NO: LS-048 **PRODUCT:** D4B-N Safety Limit Switch
DATE: December 2011 **TYPE:** Discontinuation Notice

Partial Discontinuation of D4B-N Metal-Body Safety Limit Switches

Discontinued Product Model D4B-1***N / D4B-3***N	Recommended Replacement Model D4B-2***N
 <p data-bbox="438 1774 722 1848">Conduit size: PG13.5 or 1/2-14NPT</p>	 <p data-bbox="1047 1837 1299 1890">Conduit size: G1/2</p>

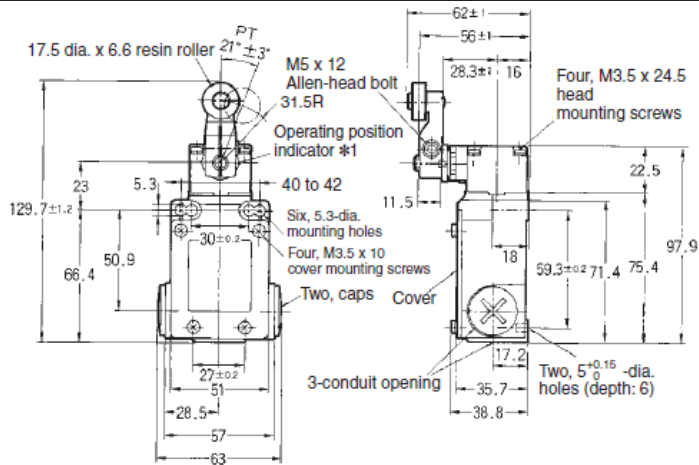
Conduit Entrance: 1/2"-14NPT versus G1/2

- same number of threads per inch: 14
- same pitch of thread: 0.07143"
- G1/2 conduit entrance does not taper but will mate with most conduit fittings

- 1/2"-14NPT and PG13.5, 1- and 3-conduit size models will be replaced by the single conduit G1/2 conduit versions
- All 3-conduit versions will be migrated to single conduit versions in available models
- Switch item numbers ending with the following suffixes will no longer be available and the switch must be re-specified; 1R: Roller Lever, Cat whisker, 81: Coil Spring, 87: Plastic rod
- Replacement parts will no longer be available, an entire replacement switch must be ordered
